SUPER STAR CAR WASH - FALCON MARKETPLACE LOT 10
SITE DEVELOPMENT PLAN

SHEET
DR1.0

Lighting Plan_V1.pdf Markup Summary

DESIGN SWK	DRAWN SWK	CHKD TOP
SCALE	H: V:	
JOB No.	020441-01-001	
DATE :	02/05/2021	
SHEET		
DR2.1

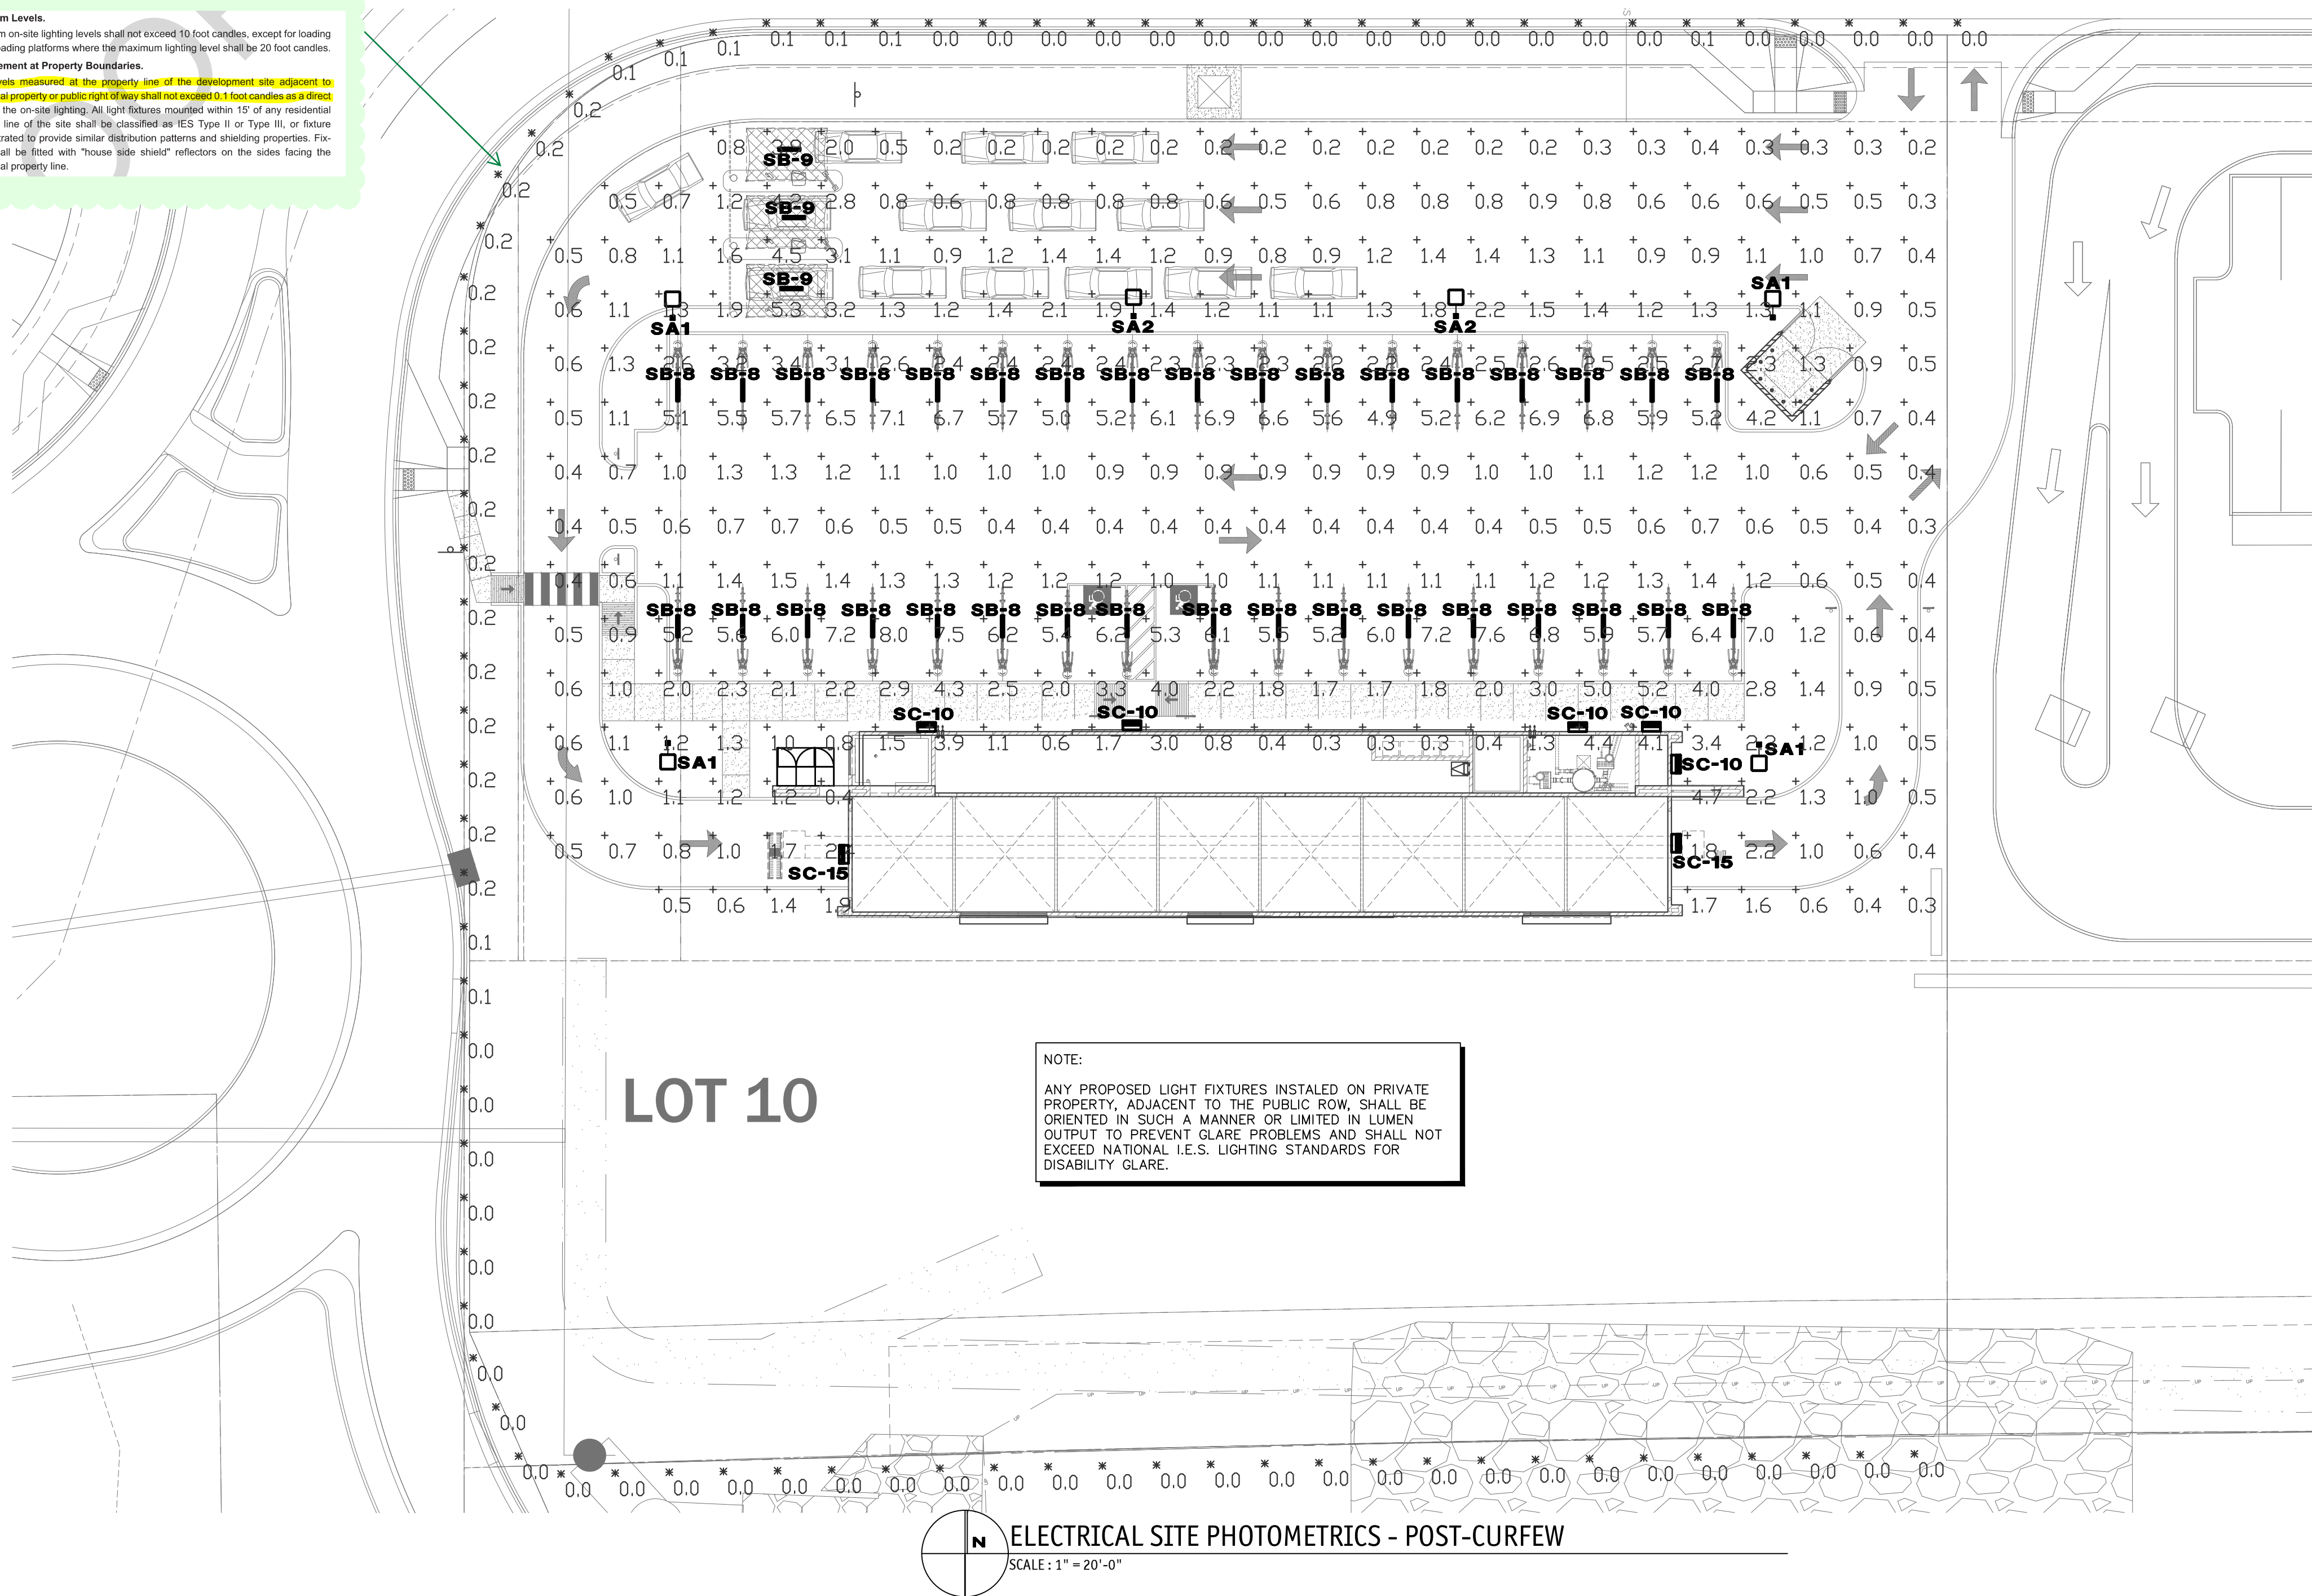
Footcandles exceed allowable limits at property boundaries along right of way. Per LDC Ch. 6 Lighting Standards:

- (d) **Maximum Levels.**
Maximum on-site lighting levels shall not exceed 10 foot candles, except for loading and unloading platforms where the maximum lighting level shall be 20 foot candles.
- (e) **Measurement at Property Boundaries.**
Light levels measured at the property line of the development site adjacent to residential property or public right of way shall not exceed 0.1 foot candles as a direct result of the on-site lighting. All light fixtures mounted within 15' of any residential property line of the site shall be classified as IES Type II or Type III, or fixture demonstrated to provide similar distribution patterns and shielding properties. Fixtures shall be fitted with "house side shield" reflectors on the sides facing the residential property line.
